## ***Interactive comment on “A new method to measure bowen ratios using high resolution vertical dry and wet bulb temperature profiles” by T. Euser et al.***

**T. Euser et al.**

Received and published: 9 August 2013

**Fig. 1.** Sensible heat for BR-DTS and reference techniques. Left: total height of DTS (1-2.2m and 3.2-4.8m), Right: only lower part (1-2.2m) of DTS measurements

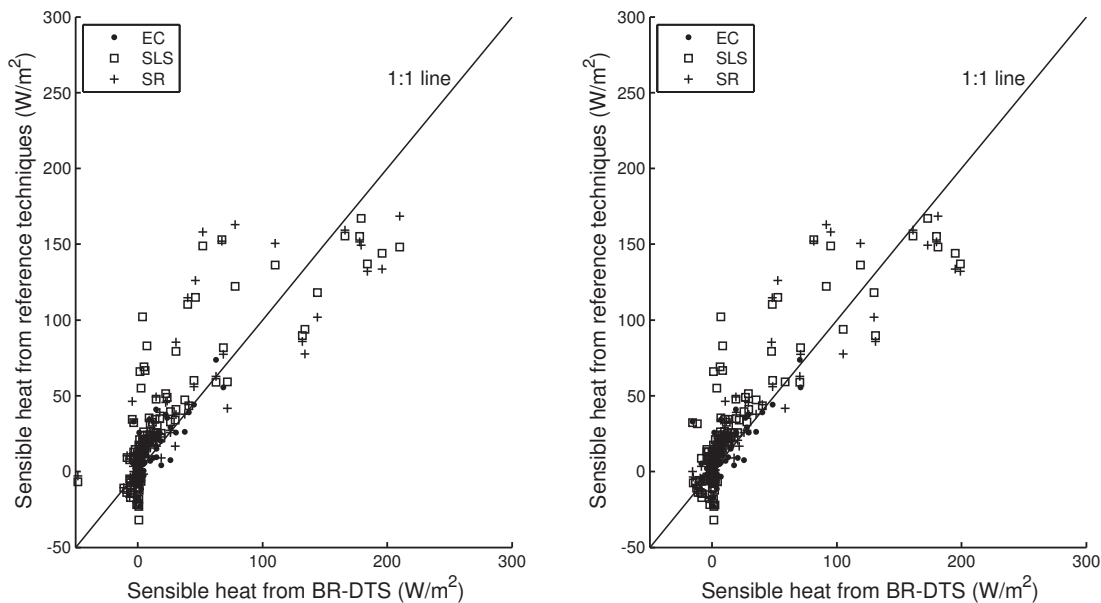
2. *The fact that what the authors refer to as the "direct EC method" does not coincide with the results from the proposed and all other energy balance methods*

*deserves more attention. I found it highly misleading to point out that the direct EC method can require corrections and dismiss of it while henceforth referring to the "indirect EC method" as "Eddy Covariance" data. To my knowledge, the direct EC method is the standard and most readers think of this method when reading "eddy covariance data". In fact, the big advantage of the EC technique is that both sensible ( $H$ ) and latent heat flux ( $LE$ ) can be estimated independently and energy balance closure can then be used as a data quality indicator. In the "indirect EC method", the authors discard the  $LE$  measurement and instead derive it by difference from the energy balance. Thus, if there is a big error in one of the other energy balance components, this error would similarly affect the  $LE$  estimates of all other methods and create a false sense of correspondence between methods. If the authors have reason to mistrust the direct EC estimate of  $LE$ , then they should compare the EC-derived  $H$  with that obtained from the new method, in order to use a direct EC measurement and avoid error propagation from the other energy balance components.*

The latent heat flux is measured with one method and the sensible heat flux with multiple. We agree that comparing the indirectly obtained latent heat fluxes leads to auto self-correlation, which is undesired. Therefore, we think it is better to compare the sensible heat fluxes of the four different methods. In figure 7, 8 and

9 of the manuscript the latent heat will be replaced by the sensible heat. Table 1 shows the results of the linear regression between all the used methods for the sensible heat. The first column shows the results for the entire height of the DTS tower and with a constant value for the psychrometric constant. However, anonymous referee #2 pointed out that the value of the psychrometric constant depends on the wind speed and that 4.8m is probably too high in comparison with the reference techniques. Therefore, Table 1 also shows the results for a variable value for the psychrometric constant and for only the lower part of the DTS measurements. It can be seen that the correlation of BR-DTS with the other techniques is comparable with the correlation between these techniques.

Fig. 1 shows the correlation between the sensible heat fluxes derived with the BR-DTS in comparison with the sensible heat fluxes derived with the reference techniques.

**Fig. 2.** Measurements of  $T$  and  $e_a$  to determine bowen ratio values. Left panel: November 17, 12:00, right panel: November 10, 14:00

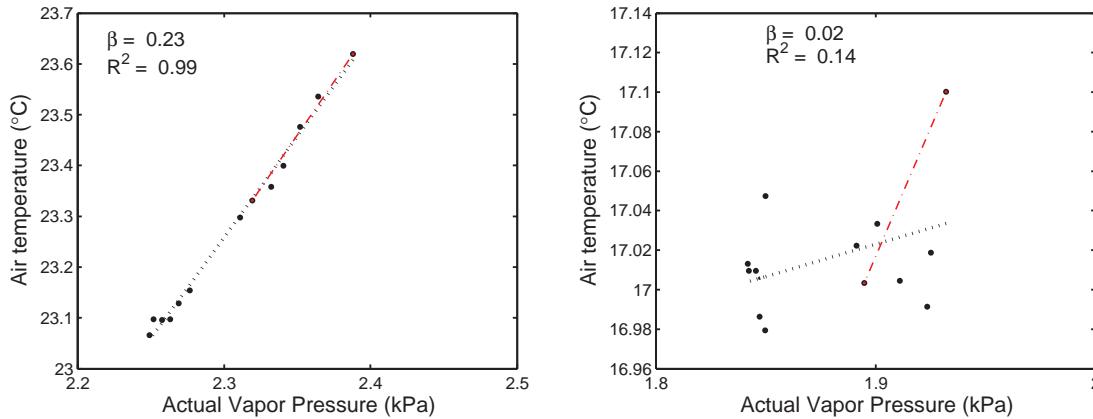
- 3. The improvement in comparison to the 2-point BR method is not very convincing. In Table 2, the authors present a decrease in standard deviations of diurnal BR estimations when using the new 13-point technique. They imply in the text that the reduction in standard deviation means "more constant results and less outliers." Without additional support, this is not convincing, as the Bowen ratio varies naturally during the day, so a decreased standard deviation in the measurements could also stem from missing part of the natural variability. In the conclusions, the authors claim that the new technique is less sensitive to measurement errors and showed a less spurious behaviour of the Bowen ratio values. I could not find much support for these statements in the data.*

*In the contrary, the new method failed under certain wind conditions and the evaporation from the wet cable could lead to a systematic bias.*

We acknowledge that the comparison between using 2 and 13 points is not very strong. Therefore, we will rewrite this part of the manuscript and include the following points and plots:

- The trend line between two points always has a  $R^2$  value of 1, which is a disadvantage of the 2-point BR method. By using multiple points in the vertical erroneous points can be filtered out. An example of this can be seen in Fig. 2. The red points represent the data obtained at 1m and 2m above the ground surface. On November 10 using these points leads to a large difference in the obtained bowen ratio value.

We will rewrite this paragraph and refer to the plot shown in Fig. 2.

**Fig. 3.** Left: Sensible heat flux for BR method with 2 points (1m & 2m) and with 13 points (1-2.2m & 3.2-4.8m), Right: Sensible heat flux for BR method with 2 points (1m & 2m) and with 7 points (1-2.2m)

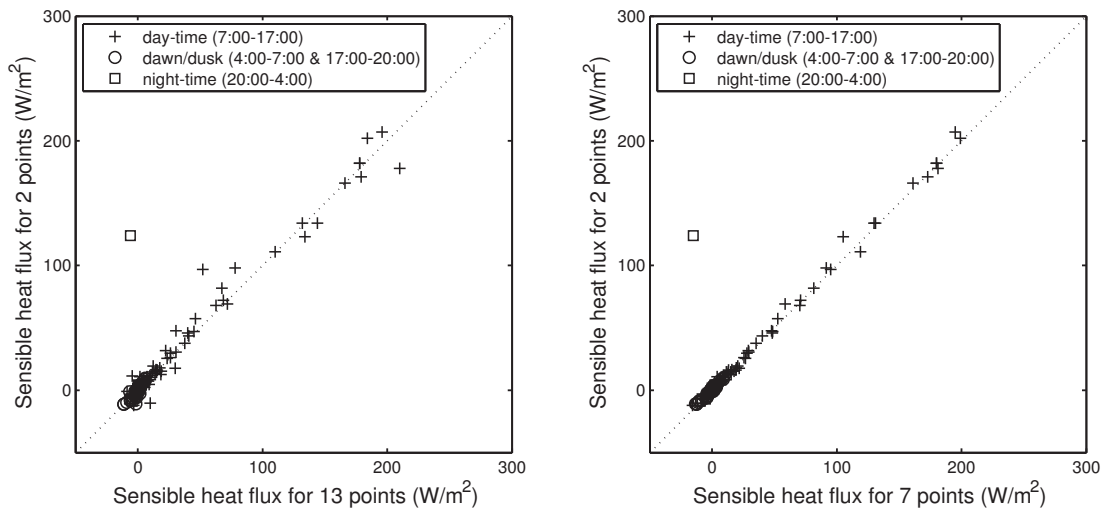
14. *P. 7176, L. 24-27: This is misleading as any absolute error in the BR will result in an infinite relative error when BR=0. Why not show absolute errors, or errors in the subsequent estimation of H and LE?*

- The relation between the bowen ratio and the derived sensible and latent heat fluxes is not linear (eq. 1 and 2). Therefore, a large deviation in bowen ratio does not necessarily lead to a large deviation in the derived fluxes. Fig. 3 shows the sensible heat for using 2 and 13 points, different symbols indicate different moments during the day. It can be seen that differences between the two methods occur on different moments during the day. It can also be seen that the results are influenced by the height of the BR-DTS measurements.

By rewriting the comparison between 2 and 13 points, we will include a comparison of the sensible heat obtained by the two methods (Fig. 3) (see also our remark at general comment 3)
